### Proposed Revisions to a Standard Plans Index

Index Number: 700-091

Index Title: Catwalk Details

**CATWALK ASSEMBLY**  
(Cantilever Shown, Span Similar)

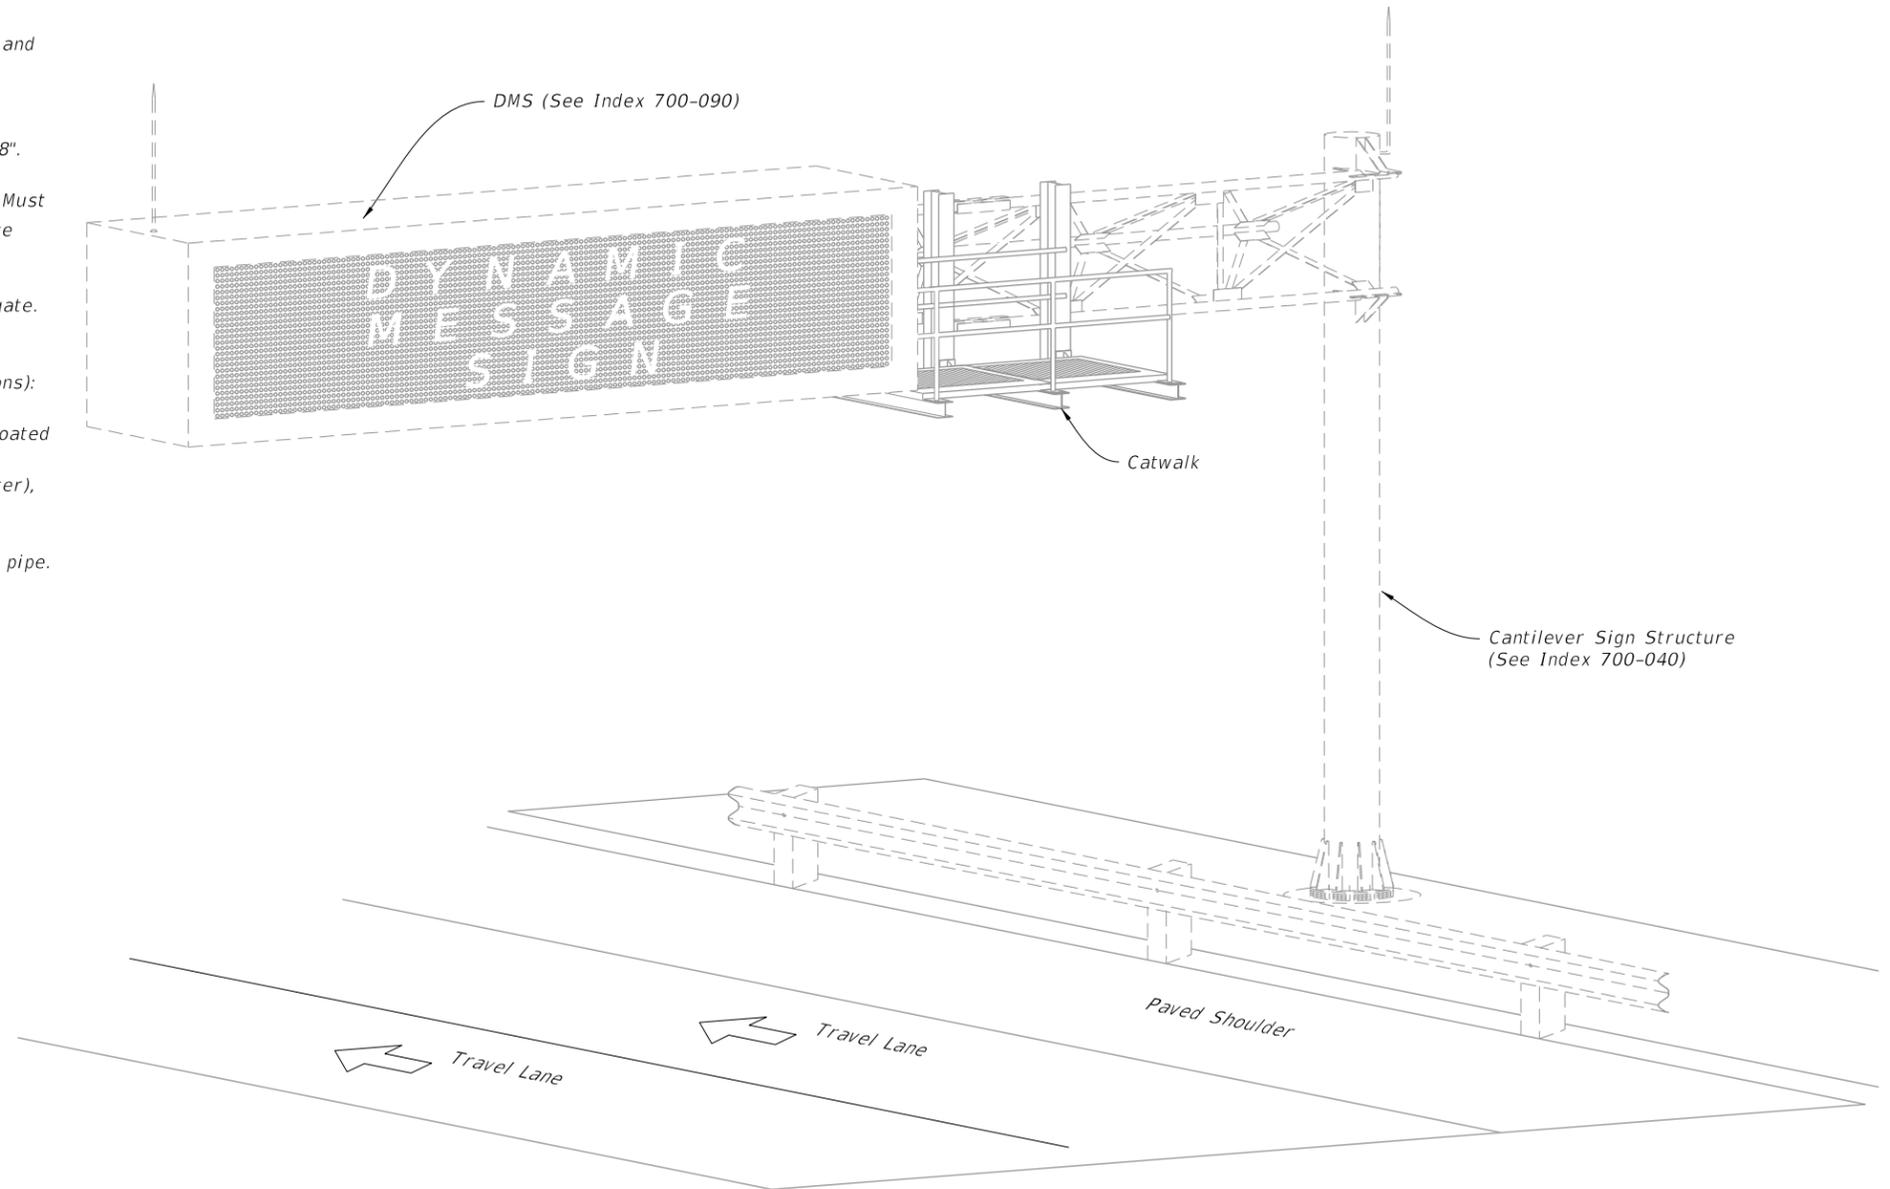
Updated General Note 1 - "Meet the requirements of Specification 700."; Deleted Note 9 through 11; Renumbered General Notes.

**UPDATED NOTE: Meet the requirements of Specification 700.**

**GENERAL COMMENT: Some material information was deleted. Information is either already covered in Standard Specifications OR will be added to Section 700, 962 or 965 in conjunction with these revisions.**

- ~~9. Welding:  
E70XX~~
- ~~10. Materials:
  - A. Steel Plates ASTM A 36 or A709 Grade 36.
  - B. W- Sections: ASTM A572 Grade 36 or 50.
  - C. Steel Pipe Railings or Structural Tubing: Specification 962
  - D. High Strength Bolts, Nuts and Washers: Specification 962
  - E. U-Bolts, nuts and washers: Specification 962~~
- ~~11. Coatings/Galvanizing:  
Hot dip galvanize support frame after fabrication and galvanize non-stainless steel fasteners in accordance with Specification 962.~~

1. Meet the requirements of Specification 700.
2. Shop Drawings are required:
  - A. Provide length as shown in the Plans
  - B. Design in accordance with AISC, AASHTO, and OSHA requirements
